AEP:NRC:3054-06  
10 CFR 2.202

Donald C. Cook Nuclear Plant Unit 1 and Unit 2  
RESPONSE TO REQUEST FOR ADDITIONAL INFORMATION  
REGARDING RELAXATION OF REACTOR PRESSURE VESSEL HEAD  
PENETRATION INSPECTION REQUIREMENTS IN NUCLEAR  
REGULATORY COMMISSION ORDER

## ATTACHMENT 1 TO AEP:NRC:3054-06

### RESPONSE TO REQUEST FOR ADDITIONAL INFORMATION

Sketch of D.C. Cook Unit 1 and Unit 2 Reactor Vessel Head Penetration  
(Not to Scale)

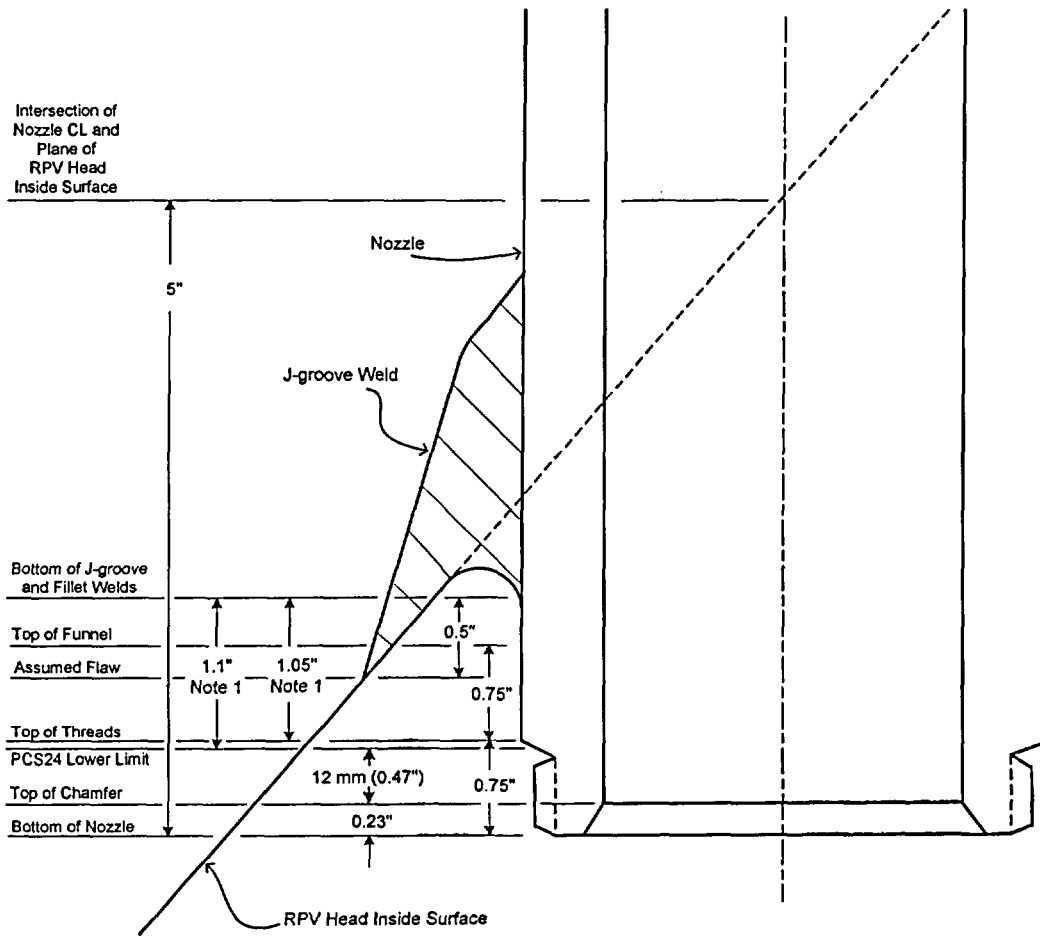
The licensee stated that a small portion of base material will not be scanned on the bottom of the nozzle because the lower transducer and the upper transducer of the probe need to be in contact with the nozzle material. The distance from the bottom of the nozzle upward that cannot be scanned is 12 mm. Please identify the minimum distance from the J-groove weld to the location on the nozzle that cannot be scanned.

The licensee is requested to provide a sketch of the nozzle with the necessary dimensioning to clarify the areas covered by the request.

Provide the distance from the bottom of the weld to the point where ET/PT cannot be performed.

As shown in the sketch provided at the end of this attachment, the distance from the bottom of the nozzle upward that cannot be scanned due to the PCS24 probe transducer arrangement has been calculated to be 12 millimeters (0.47 inches) plus the height of the chamfer (0.23 inches). The minimum distance downward from the J-groove weld to the location on the nozzle that cannot be ultrasonically scanned due to the PCS24 probe transducer arrangement has been calculated to be 1.1 inches. Due to the curvature of the RPV head, this minimum distance only occurs at one point on the downhill side of the outermost penetrations (six penetrations on Unit 1 and five penetrations on Unit 2).

A sketch has been provided at the end of this attachment.

The nozzles that have guide funnels installed are the outermost nozzles. As shown in the sketch provided with this attachment, the guide funnels extend approximately 0.75 inches above the threads. Consequently, the minimum distance from the J-groove weld to the location on the nozzle that cannot be examined by eddy current testing or dye penetrant testing on nozzles that have funnels installed is less than the distance assumed in the crack growth calculation described

GRAPHS OF STRESS VERSUS DISTANCE BELOW J-GROOVE WELD

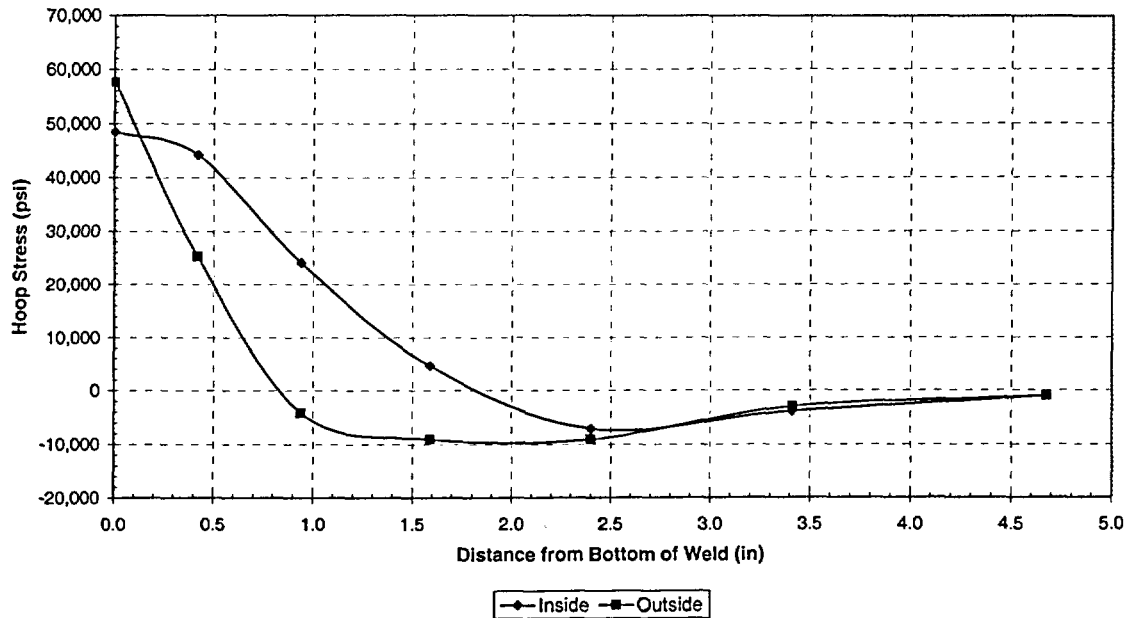
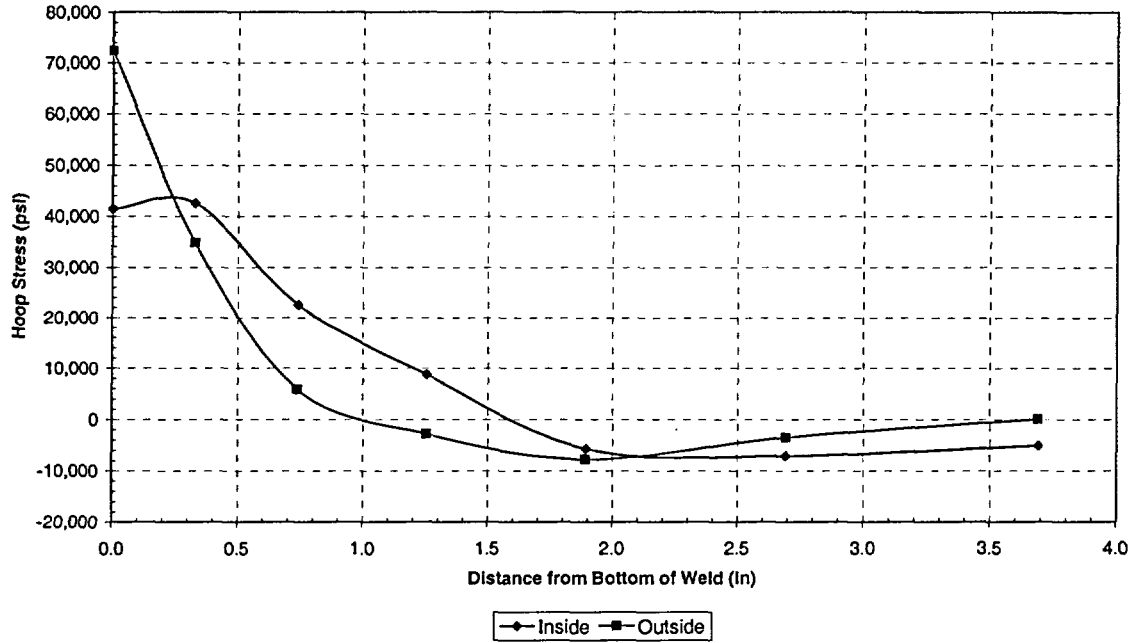
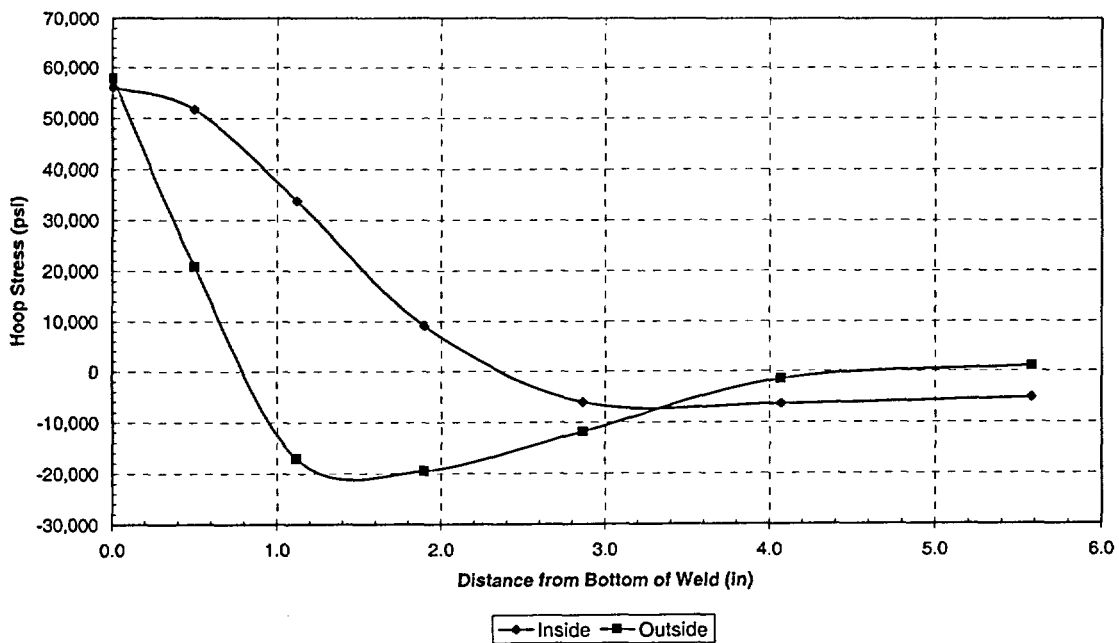
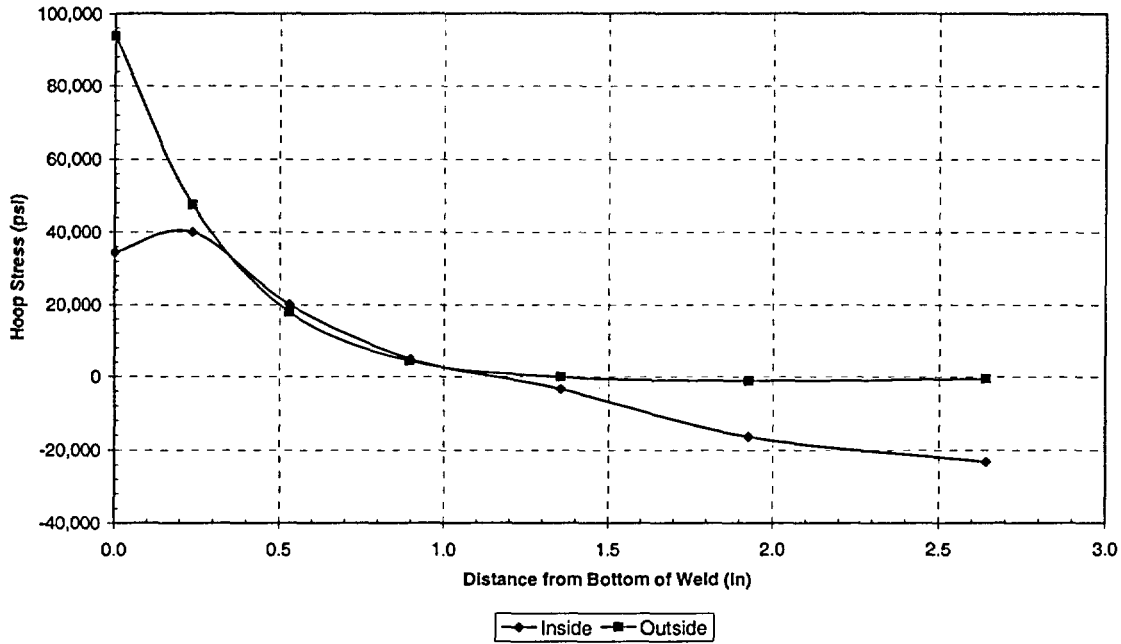
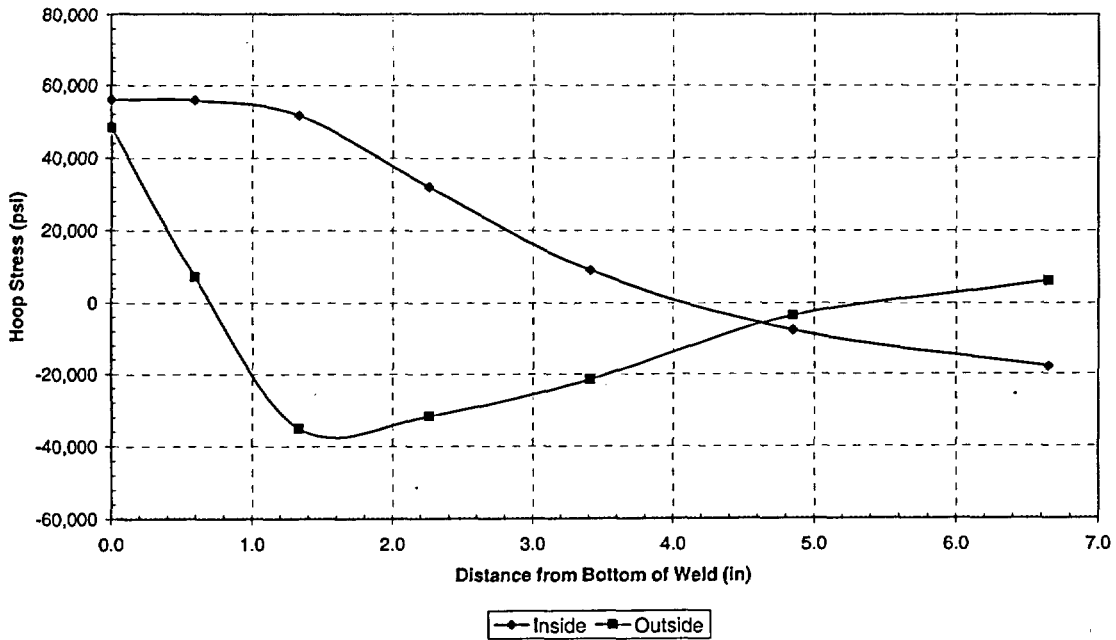
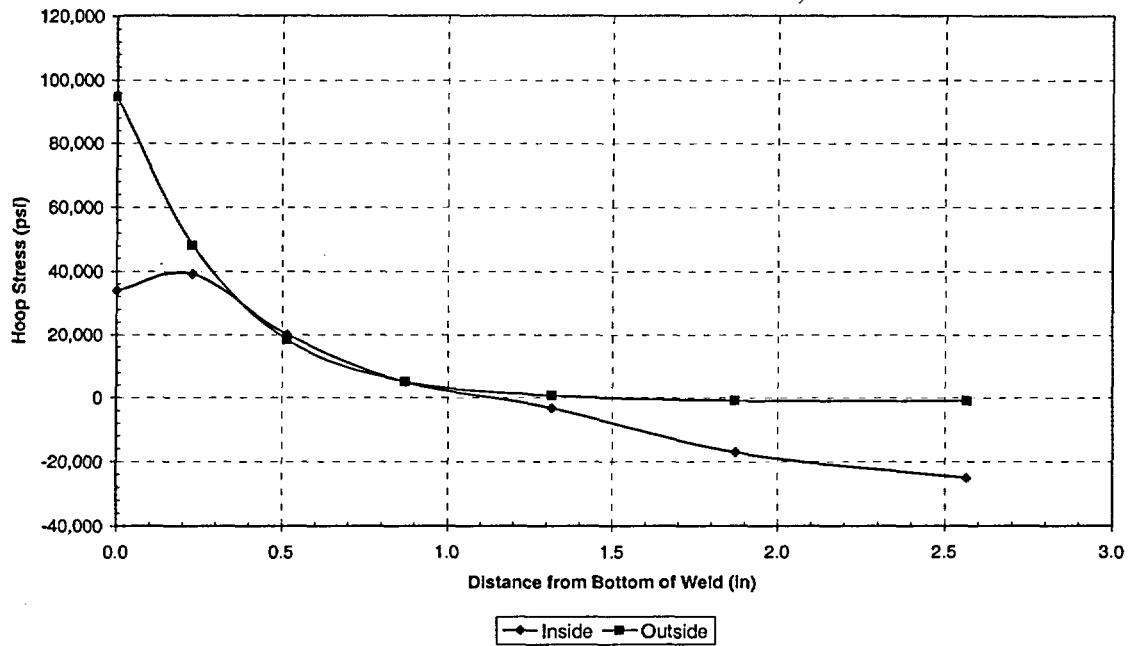
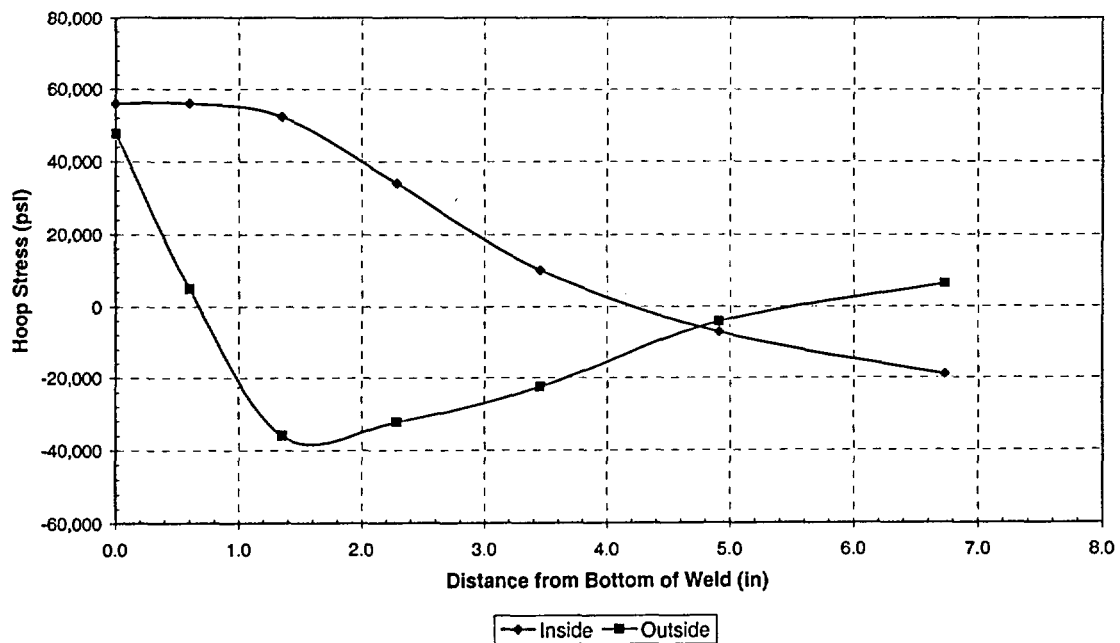
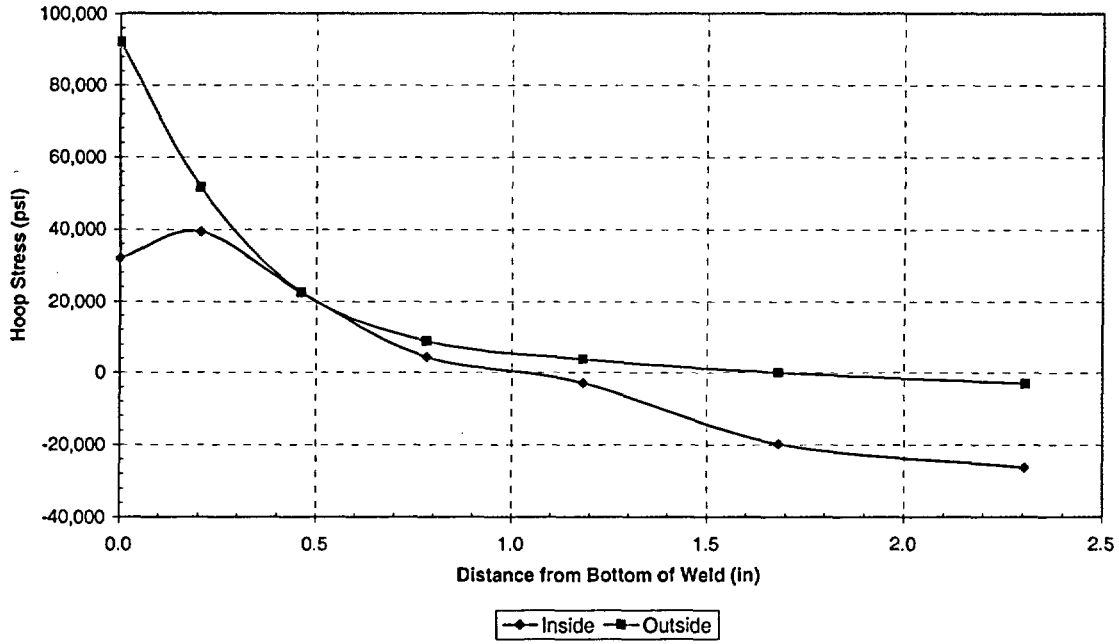
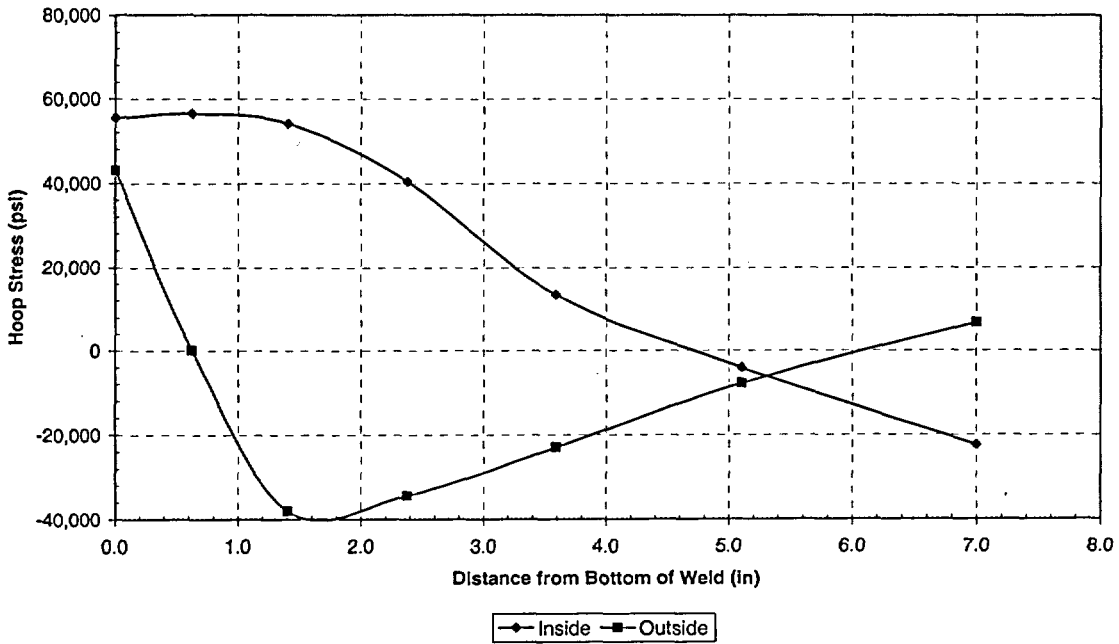
Provide additional technical justification (i.e., operating stress levels, crack growth analysis, etc.) that supports the licensee's statement that the small area that cannot be scanned is insignificant to the phenomena of concern.

The operating stresses in that area are shown in Attachment 2 to this letter, which provides graphs of hoop stress versus distance below the J-groove weld for various nozzles from the center of the Unit 2 RPV head to the outermost row. As shown in these graphs, the stresses in the area of the nozzle that would not be inspected are low relative to the yield stress of the nozzle material (41,000 to 63,000 pounds per square inch).

The minimum distance from the J-groove weld to the threaded area has been calculated to be 1.05 inches. Due to the curvature of the RPV head, this minimum distance only occurs at one point on the downhill side of the outermost penetrations (labeled 50.5° in Attachment 2, six penetrations on Unit 1, five penetrations on Unit 2). The minimum distance from the J-groove weld to the threaded area for all other points on these penetrations, and for all points on the other 73 penetrations, exceeds this value. As indicated in the response to NRC Question 1 above, the minimum distance from the J-groove weld to the location on the nozzle that cannot be ultrasonically scanned due to the PCS24 probe transducer arrangement has been calculated to be 1.1 inches. Since this value is approximately equal to the 1.05 inch minimum distance to the threaded area, the minimum distance from the J-groove weld to the location on the nozzle that cannot be ultrasonically inspected due to both causes will be considered to be approximately 1 inch.
